# Shire Of Esperance

## Esperance Tanker Jetty Remediation Options Review

### Independent Peer Review

November 2016

**STAGE 5**  
SCALE 1 : 50

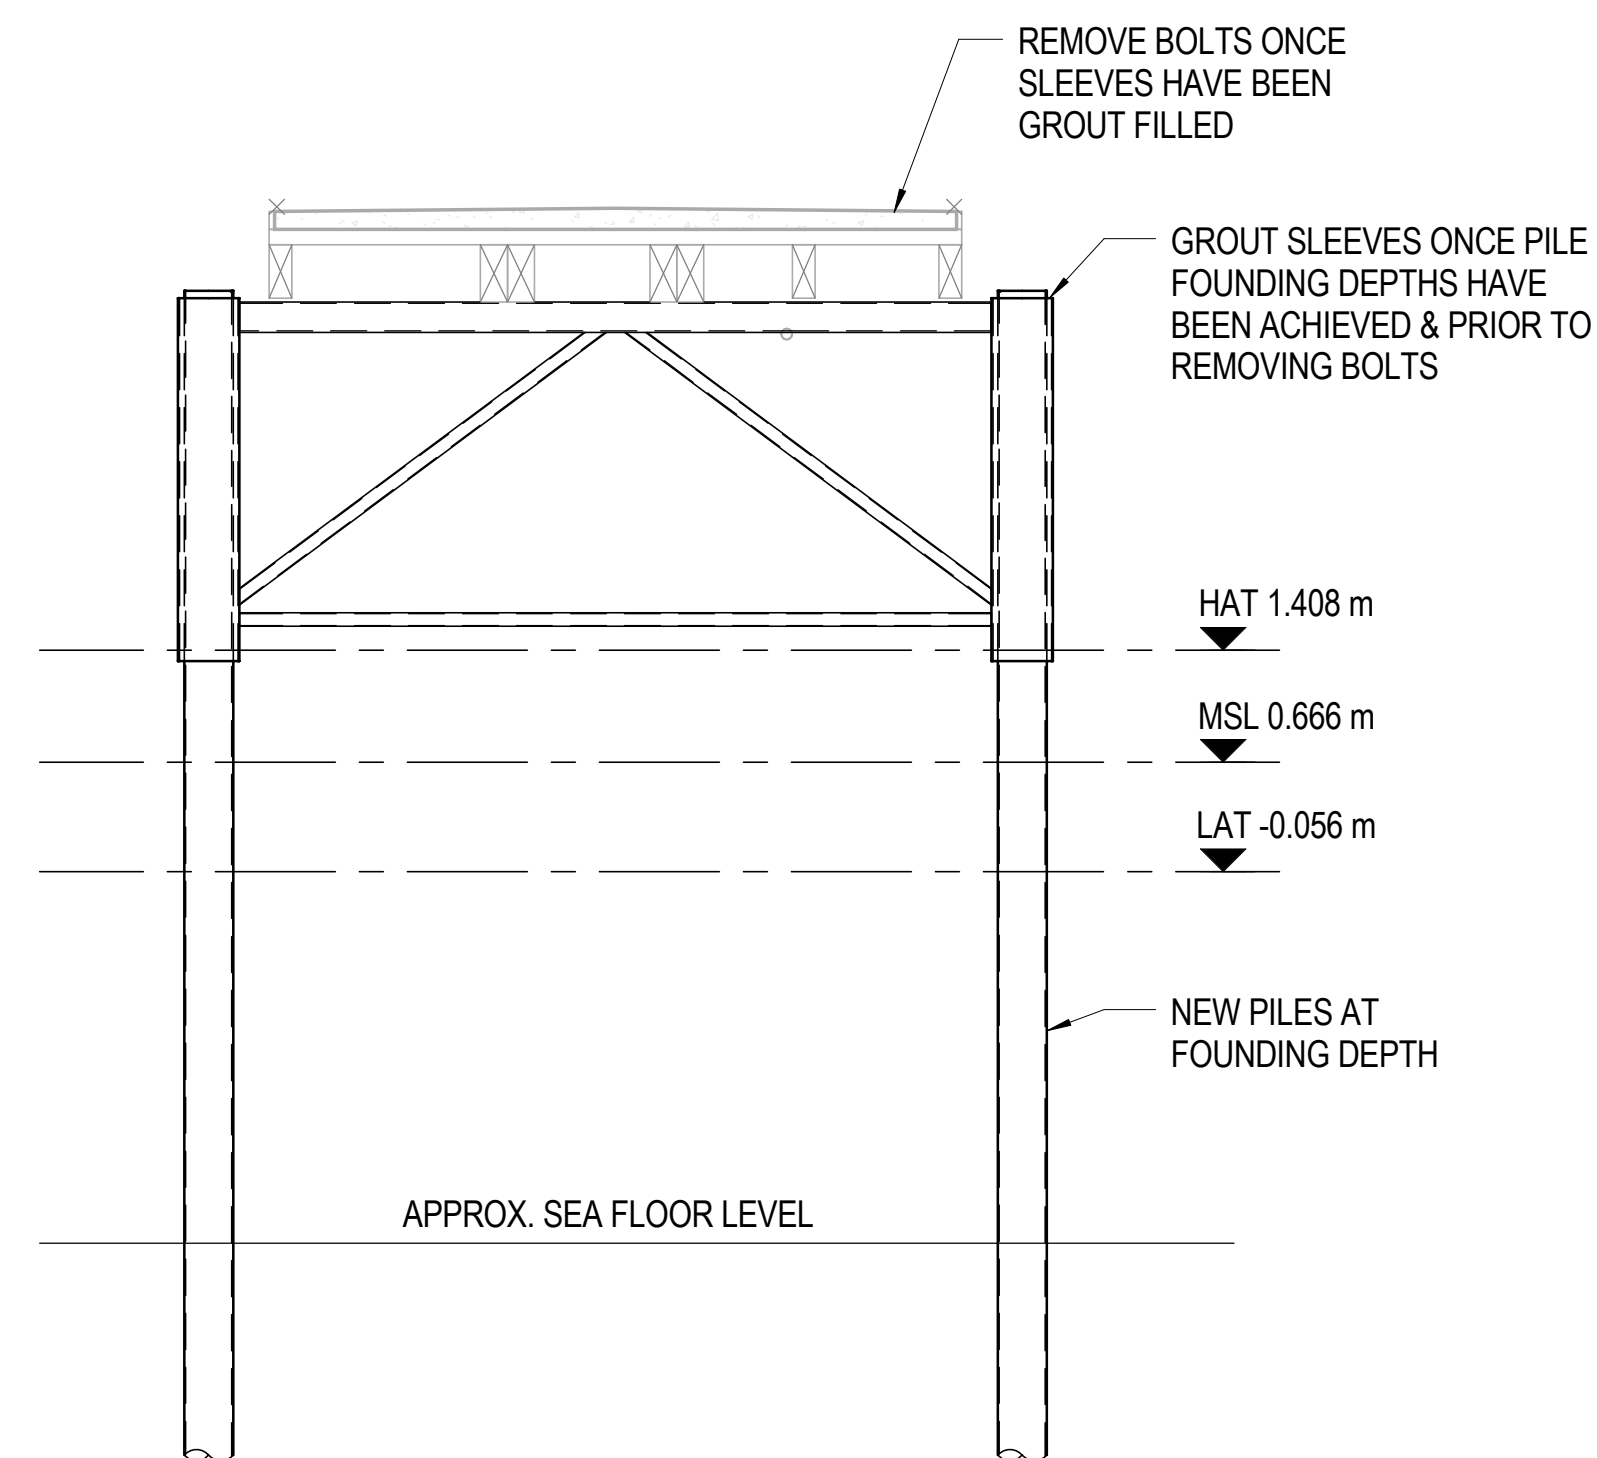
6. The pile installation for both vertical and raked piled will need to be via a barge or water based plant as the existing deck is unlikely to support the construction loads;
